Efland Interstate Overlay District

Efland Village Overlay District

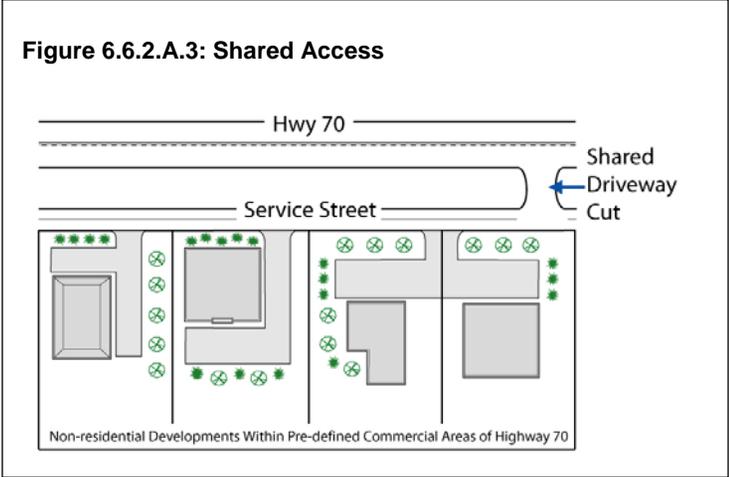
5.	6.6.3 (A)(2)	All site planning west of Mount Willing Road shall take into account: (a) A possible re-alignment of Efland-Cedar Grove Road under the existing railroad track to connect to Mount Willing Road, as described in the adopted Efland-Mebane Small Area Plan. (b) The need for a connecting roadway between Mount Willing Road and Buckhorn Road, as depicted on the Efland-Buckhorn-Mebane Access Management Plan, adopted November 11, 2011.	The small area plan calls for future re-alignment of Efland-Cedar Grove Road under the railroad track in order to both improve traffic flow and safety in the area by minimizing the number of at-grade railroad crossings and to attempt to ensure that emergency vehicles are not held up at the rail crossing when trains are going by. Although this project is likely far in the future (due to the Department of Transportation [DOT] process to get projects programmed and funded), it is good planning practice to anticipate future needs for road right-of-way when development projects are proposed and to work with developers to ensure that both future needs are met and that future anticipated projects disrupt development as little as possible. Standard (a) achieves this idea. The explanation for proposed standard (b) is the same as the explanation for 6.6.3(A)(1) immediately above ("Easy Reference Number" 4).

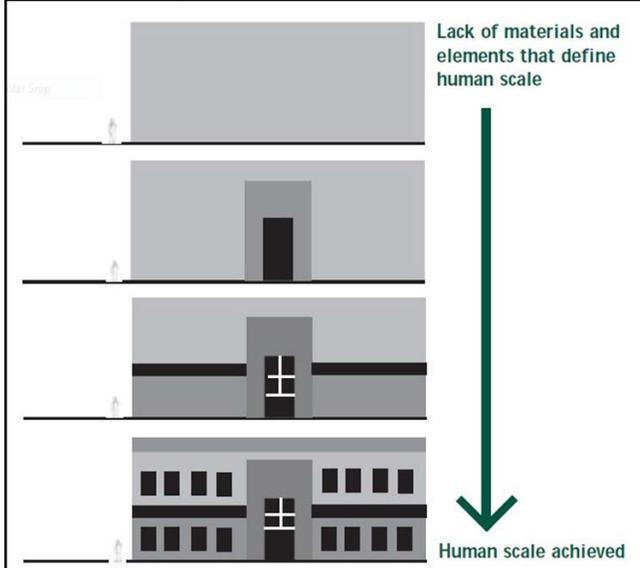
44.	6.6.4 (D)(2)	Shared parking areas shall be encouraged for contiguous non-residential land uses, in accordance with Section 6.9 of this Ordinance.	This standard attempts to encourage shared parking among contiguous uses, if they meet the requirements of Section 6.9 of the UDO (which addresses distance requirements and peak usage time). The idea is to both limit the amount of impervious surface in the area and address the visual impacts that parking areas can cause in urban/suburban areas.
